Dutchman's Pipe Cove Roofing Maintenance

Re: Dutchman's Pipe – Water intrusion in rear of various units

The purpose of this letter is to address our inspection of the roof leak concerns on the rear of the Unit 28 at 2808 Dutchman's Pipe in Greensboro, North Carolina. The inspector from our company visited the jobsite on December 1st, 2009 to inspect, photograph, and measure the area of concern.

S1

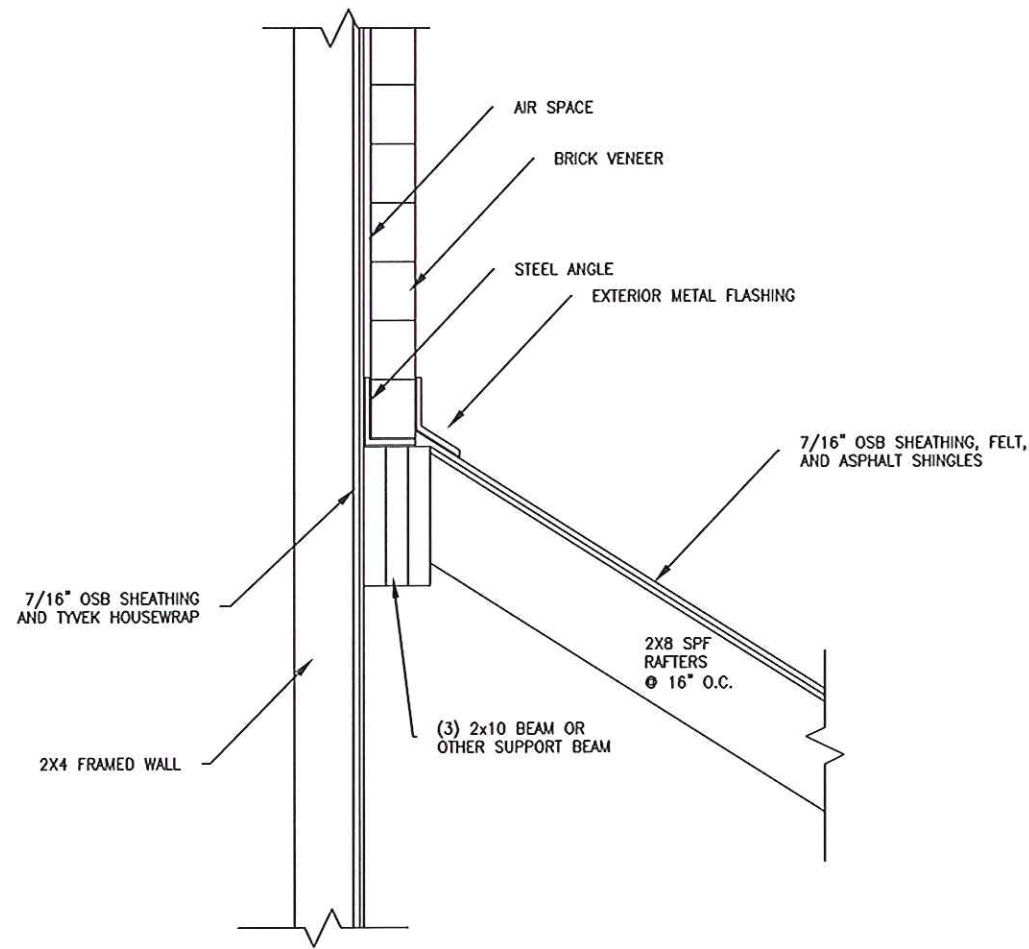
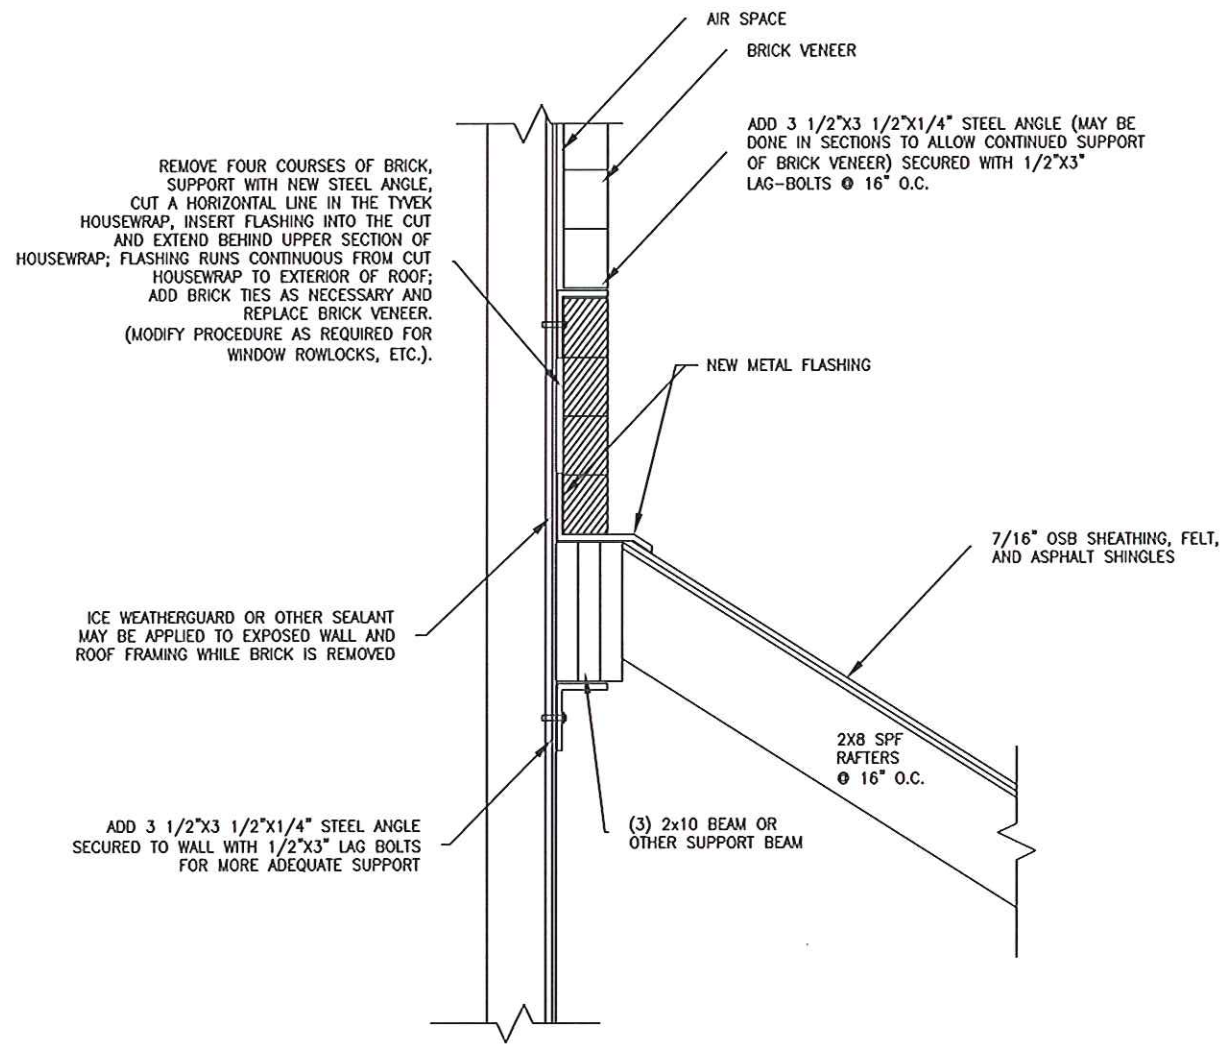
It is my opinion that the water entering the ceiling below is passing through the brick veneer and traveling down the house wrap into the attic space (see enclosed sketches). This may be alleviated by either preventing the water from penetrating the brick or channeling it to the roof below before it enters the space over the ceiling.

I recommend that a lower section of the brick veneer be removed and a more permanent solution be implemented. This method is outlined on the two enclosed sketch pages.

This solution offers the best long term protection from future water intrusion into the home at this location.
